City of Portland, Maine - Building or Use Permit Application

Location of Construction: <i>units #3 & 4 Meadow Woods</i>	Owner Name: Rodway Charles	Owner Address: 70 Jordan Shore Dr Poland, Me 04274	Phone: 207-878-2241
--	-------------------------------	---	------------------------

**CITY OF PORTLAND, ME
BOCA 1999 Plan Review Record
One and Two Family Dwelling**

Building Location: UNITS 3 & 4 Leisure Lane - Meadow Woods
~~42 Harrison St~~ CBL: 336-L-008

Stairs

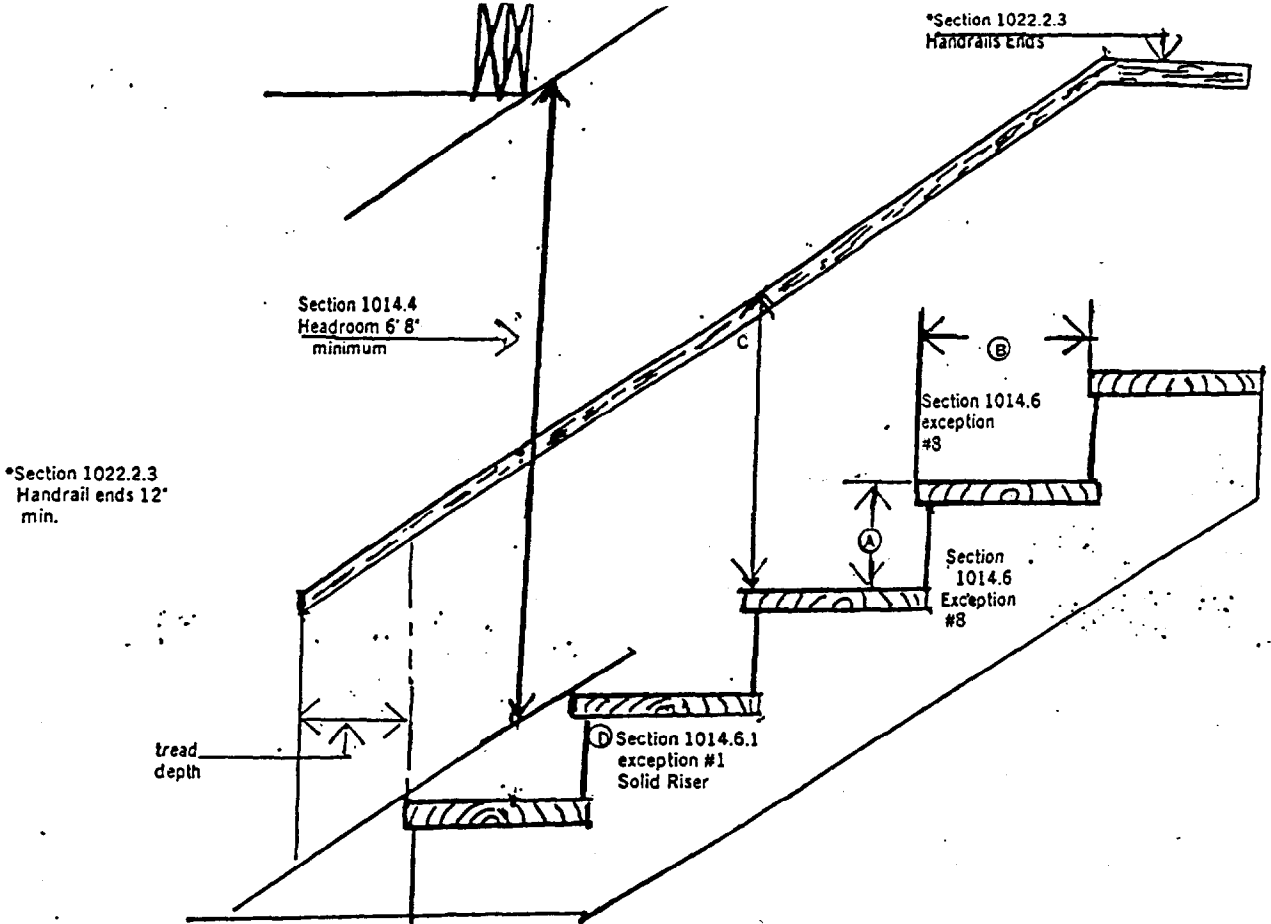
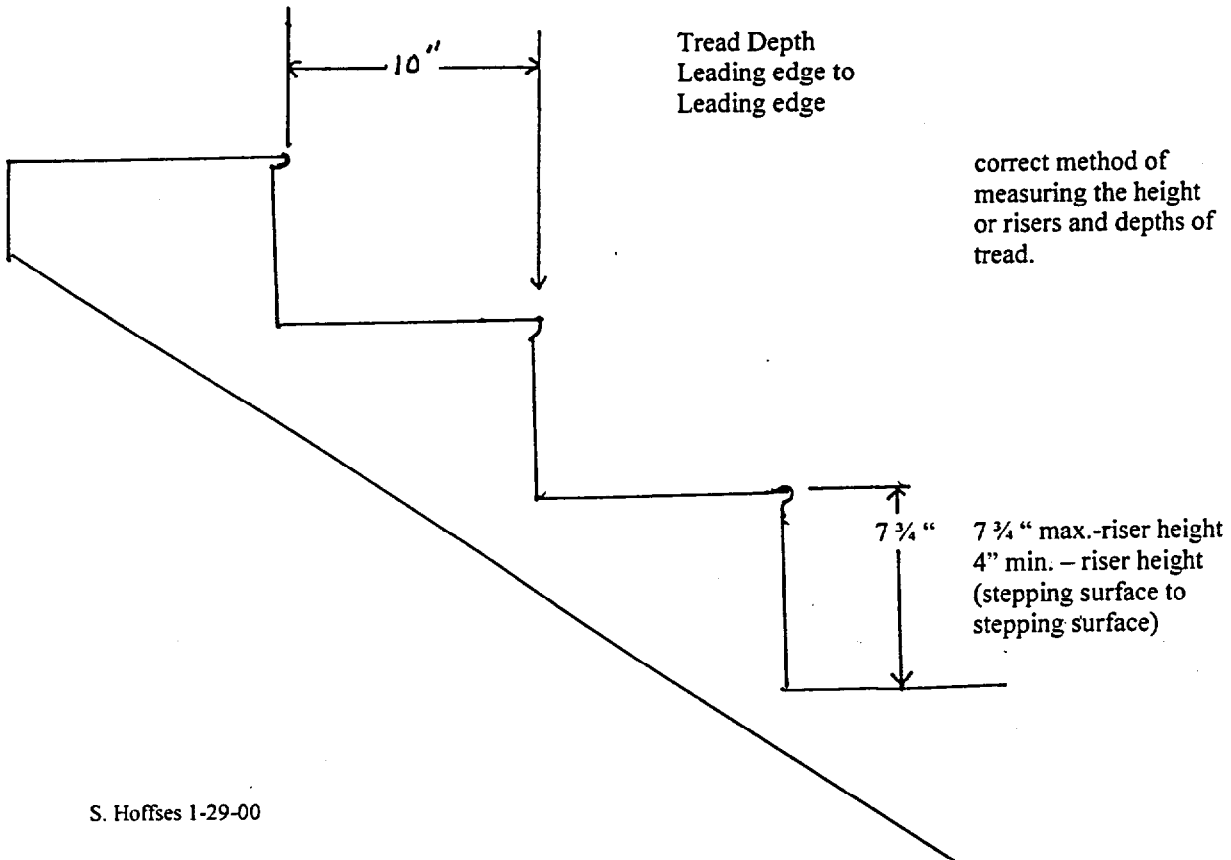
12. Headroom in habitable space is a minimum of 7'6". (Section 1204.0)
13. Stair construction in Use Group R-3 & R-4 is a minimum of 10" tread and 7 1/4" maximum rise. All other Use Group minimum 11" tread, 7" maximum rise. (Section 1014.0) see attached

7.	Guardrails and handrails shall comply with section 1021.0 & 1022.0	1021.0 1022.0
8.	Stair construction shall comply with section 1014.0 (See attachment)	1014.0

Section 1014.6 Exception #8	Section 1014.6 Exception #8	Section 1022.2.2	Section 1014.6.1	Section 1021
	A Maximum Riser Height	B Minimum Tread Depth	C Handrail Height Not part of Guardrail	D Solid Riser	E Guards Height
1 & 2 Family Dwelling	7 3/4"	10"	34" to 38"	4" Maximum Opening	36"
All Other Use Groups	7"	11"	34" to 38"	Different	42"
